APPLICATION FOR CONDITIONAL USE PERMIT

Case No. 87-67- CUP

NAME OF PROPOSED DEVELOPMENT Mr. M Addition

- IV. B. P&Z 87-PP/SP/CUP- Discuss and Consider Approval of a Conditional Use Permit for Gasoline Sales as an Accessory to a Retail Use and a Site Plan/Preliminary Plat for a Mr. M. Located on FM-740 and Horizon Road

1st sub

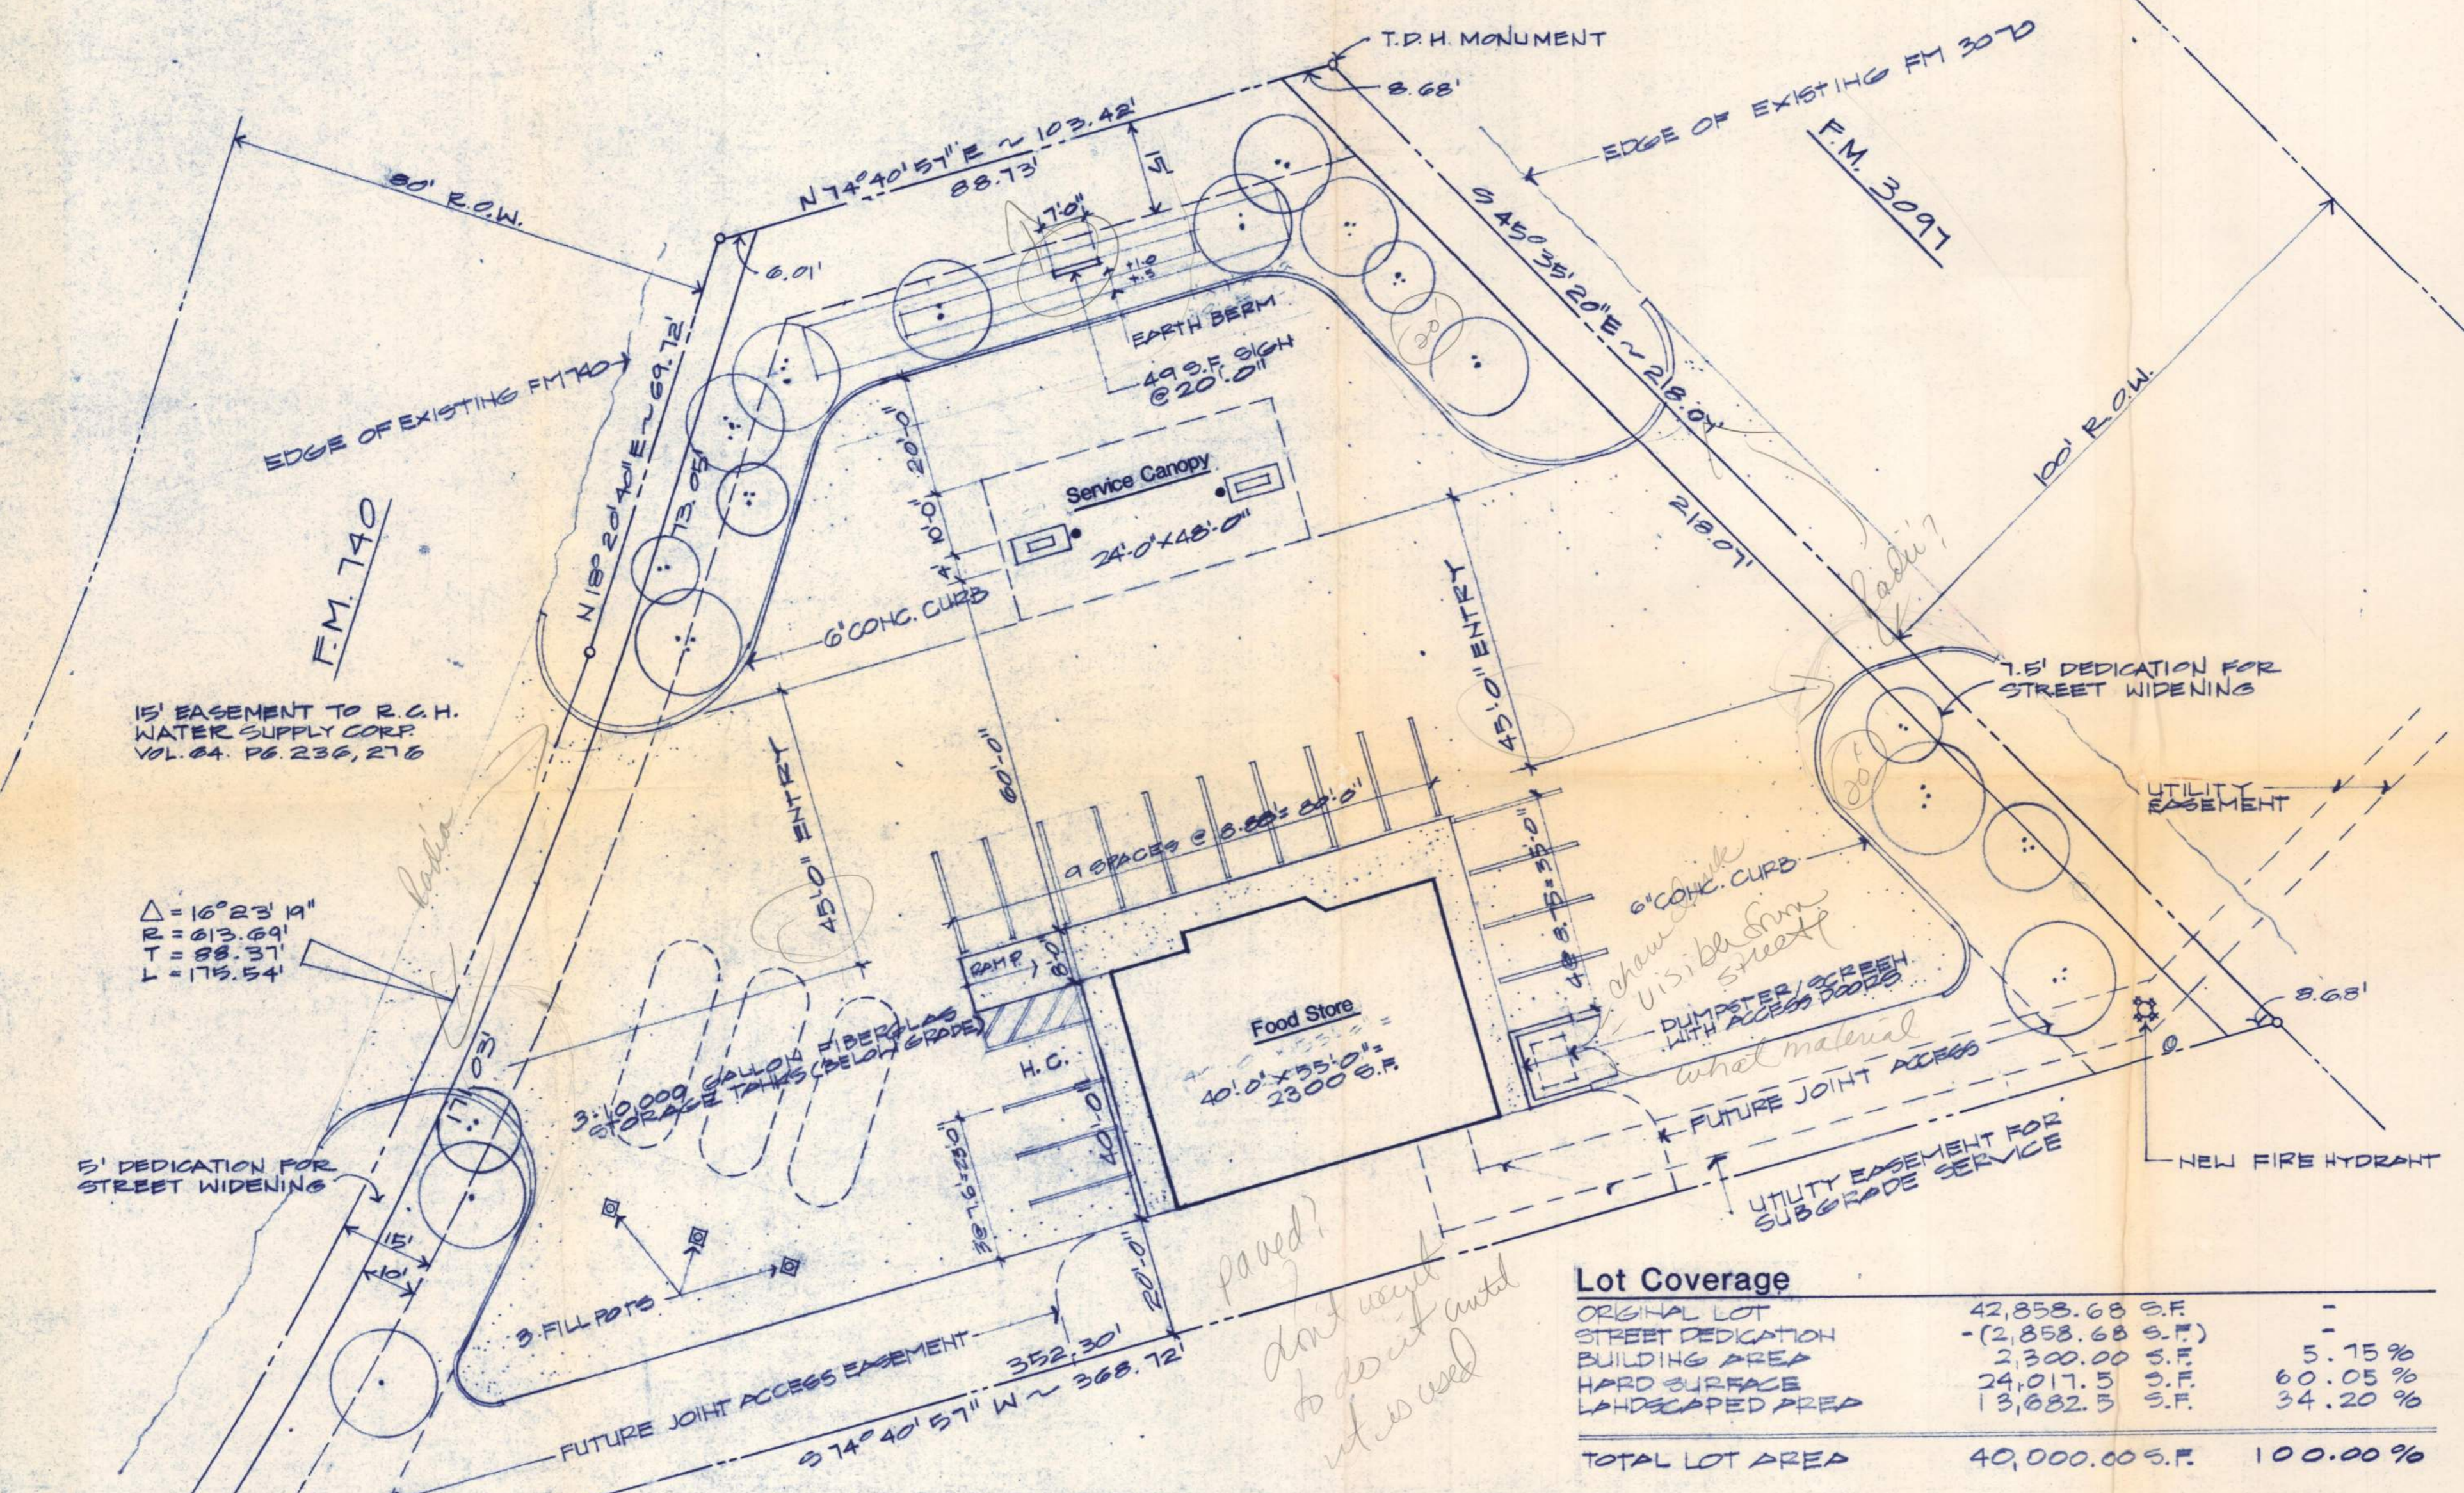
*paved?
don't want to do it until it is used*

has been corrected (APPROVED SITE PLAN) 1/4/88

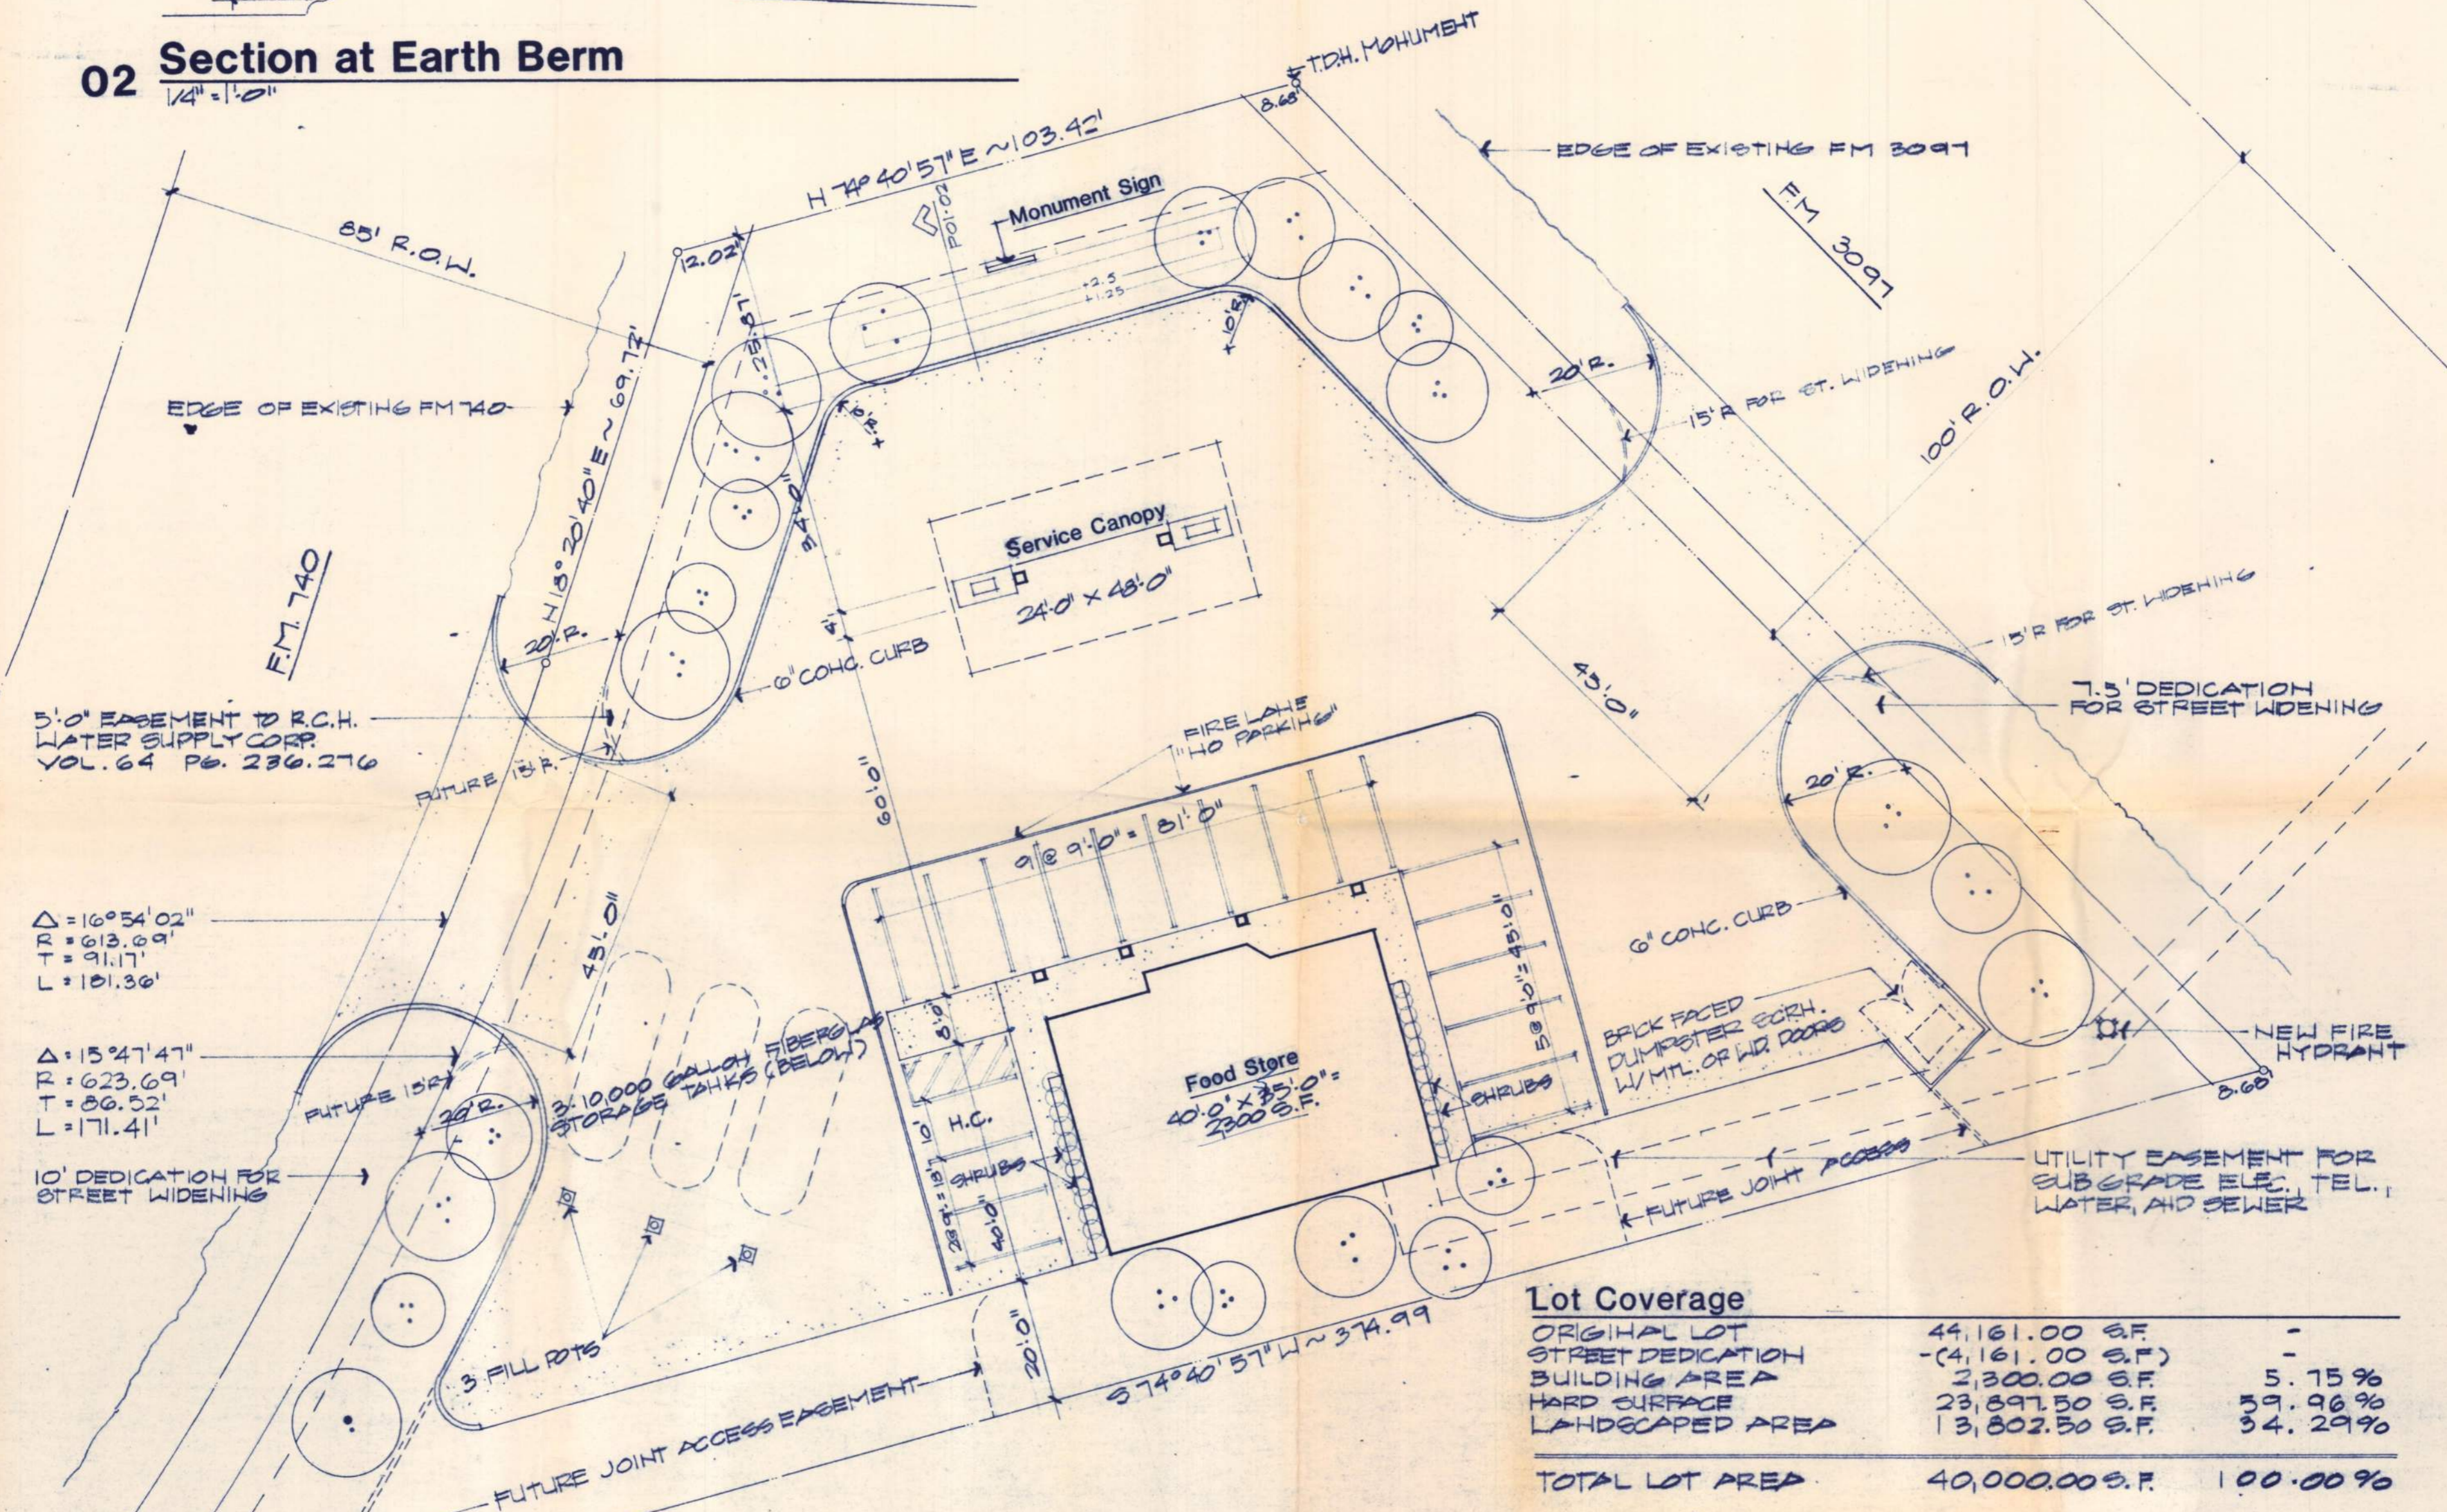
1. Consider moving the trash receptacle adjacent to the 20 foot landscape buffer, screened with a brick wall and planting, i.e., photinias and face the door to the building. This would more accurately meet the requirements of the District and would also, if it is faced at an angle, make access by a front loading trash truck easier.

2. Consider some vertical planting along the back of the building such as photinias that require little maintenance but would provide a break in the rear wall of the building.
3. Consider some requirements regarding the supports for the gas canopy. They are proposing the standard pole supports. Something similar to the brick treatment used by the Gulf Station that ties the canopy to the building might be more appropriate in the District.

- 1) move the proposed trash receptacle adjacent to 20 ft. landscaped buffer, screen with brick wall and planting facing toward the building,
- 2) elevations to conform with photos shown of the Rowlett store including color of brick;
- 3) the metal roof to be extended to all four sides of the building;
- 4) property to rear of building to be landscaped with photinias;
- 6) sidewalks on sides of building to be widened and landscaped with shrubbery adjacent to building.
